MIDDLE ST. CROIX WATERSHED MANAGEMENT ORGANIZATION

Regular Meeting of the Middle St. Croix Watershed Management Organization

Thursday, July 13th, 2023

TO: Matt Downing, Administrator
FROM: Rebecca Nestingen, PE
DATE: July 7, 2023
RE: **8a) Plan Reviews/Submittals**

Project Name: Baylon Residence **Project Address:** 165 Lakeland Shores Rd

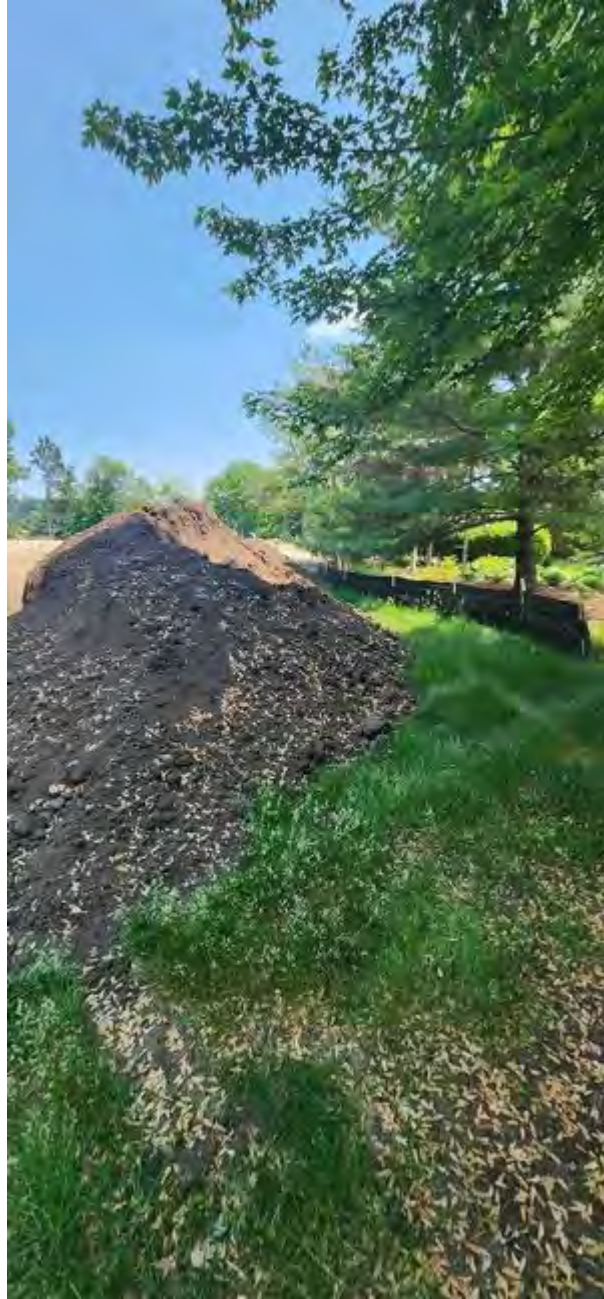
All erosion control measures installed per plan. Current footprint is per plan. Also checked boathouse, matches plan. No concerns at this time.
